July 14, 2025

**Subject: Central Reservoir Groundwater Monitoring Plan (M-2012-045)
DRMS Preliminary Adequacy Review – Response to Comments
Central Reservoir, Pueblo, Colorado; Schnabel Project No. 20C26014.06**

**Subject: Central Reservoir Groundwater Monitoring Plan (M-2012-045)
Pre-Baseline Analysis and Proposed Baseline Monitoring
Central Reservoir, Pueblo, Colorado; Schnabel Project No. 20C26014.06**

**Alluvial Aquifer
and Surrounding
Wells**
FIGURE NO. 3

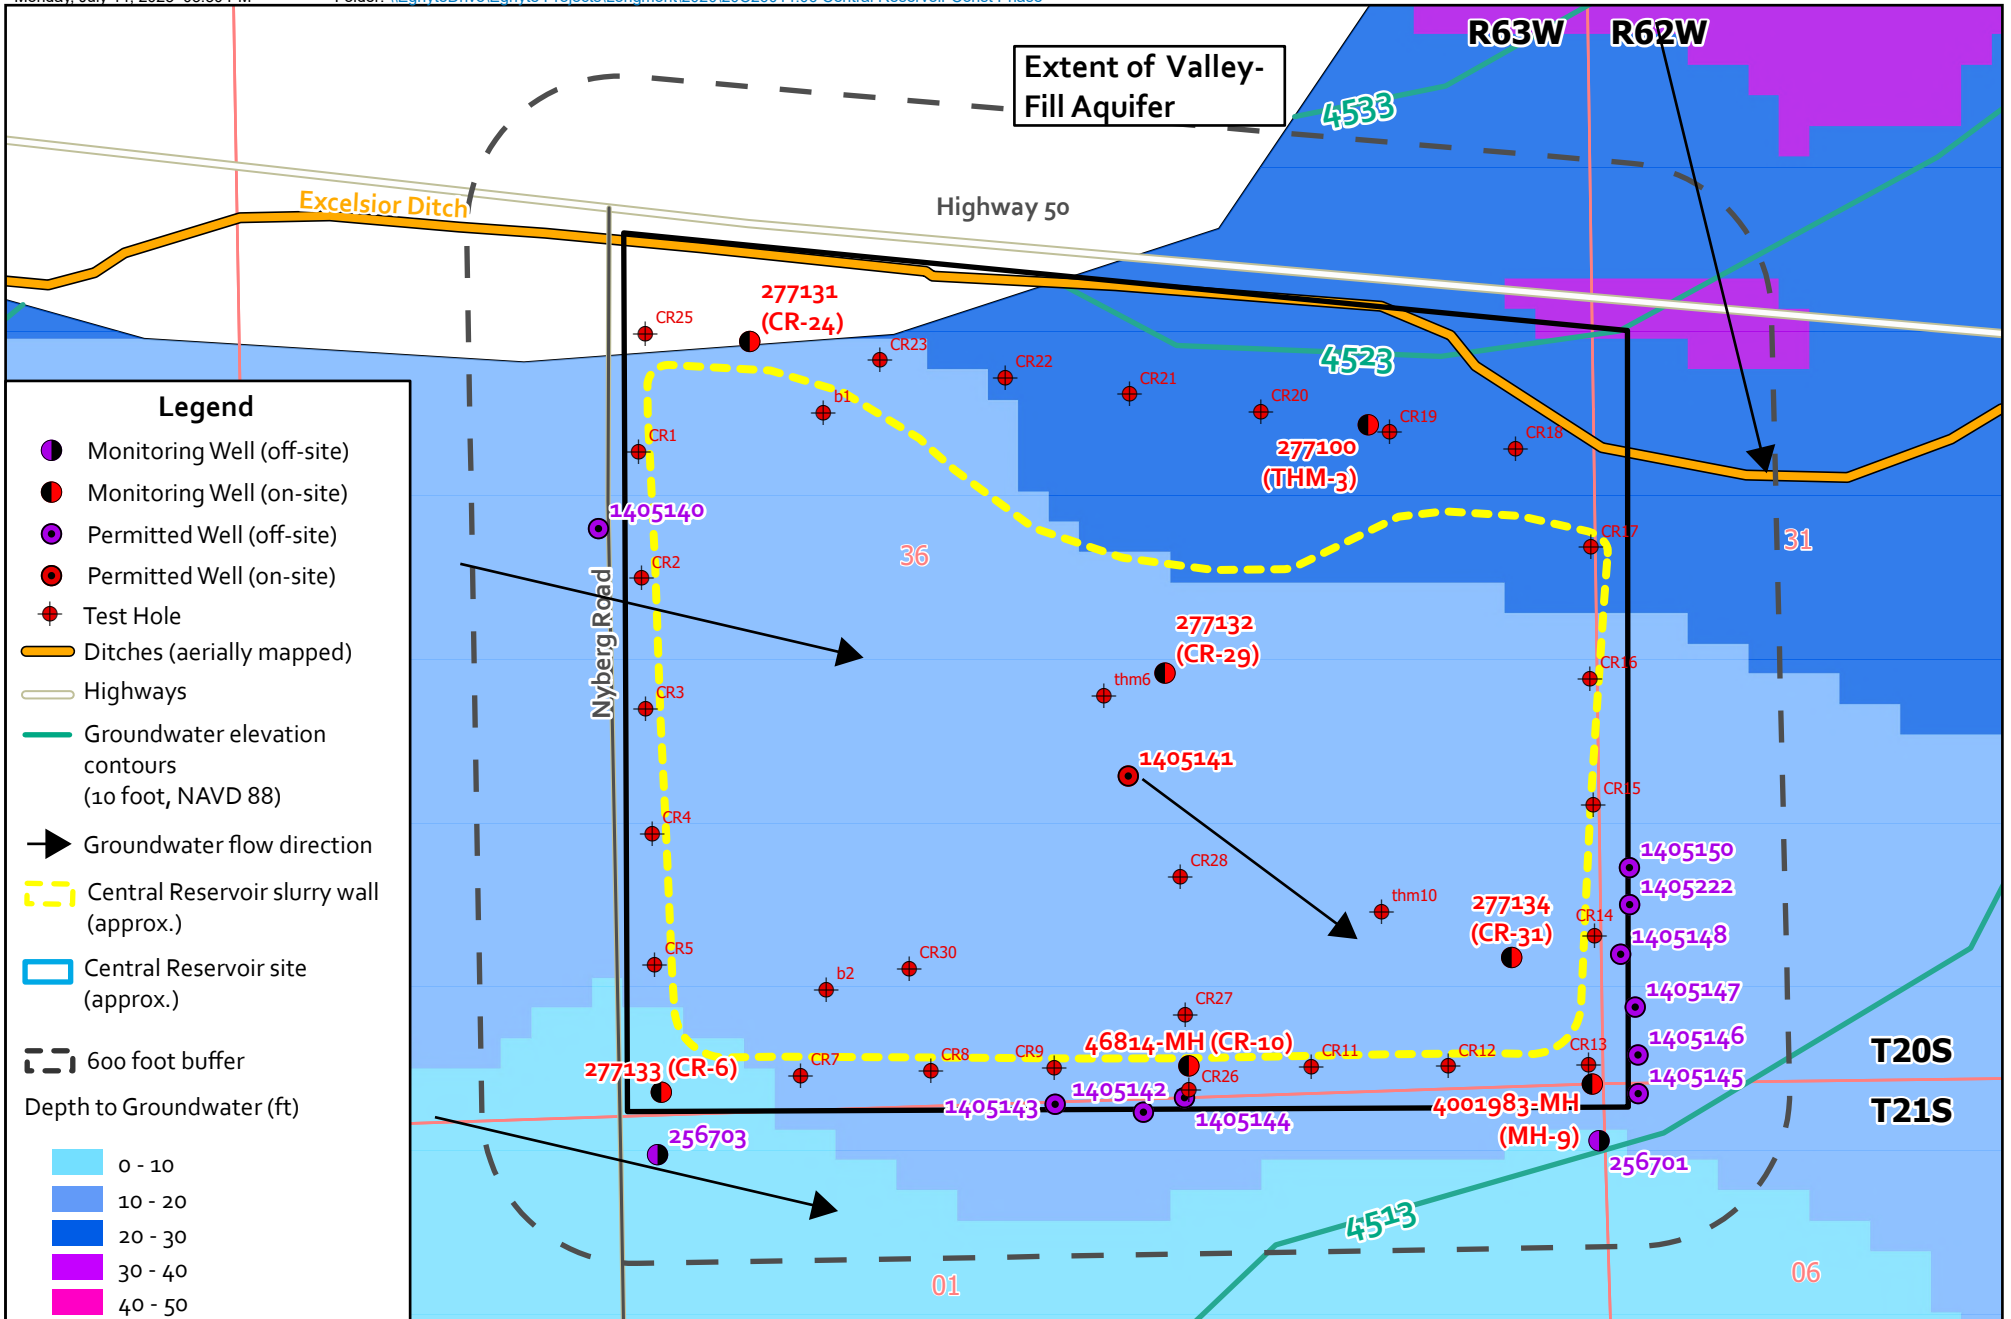
DRMS Comment #4: The proposed monitoring locations submitted in the GWMP of CR-24 to the northwest of the proposed slurry wall, CR-6 to the southwest of the proposed slurry wall, and MH-9 to the southeast of the proposed slurry wall, all of which have already been constructed, appear to be adequate. At this time, it is unclear if the depth of well MH-9 is sufficient. The depth of MH-9 appears to be constructed depth of 42.5 feet which may not be adequate for the purpose of groundwater monitoring. Provide more information about the depth to the Pierre Shale for monitoring well MH-9. Additionally, provide the construction diagrams for each proposed monitoring well, CR-24, CR-6, and MH-9.

Schnabel Response: During drilling of MH-9, the on-site geologist identified claystone bedrock contact of the Pierre Shale formation at a depth of 42.5 feet below ground surface. The well screen in MH-9 was constructed from depths 22 feet to 44 feet below ground surface and the groundwater table was measured at 15.5 feet below ground surface during drilling. The summary log and well construction report for CR 24 and CR-6 are included in Attachment 1, Figure 3.2 and Attachment 2.
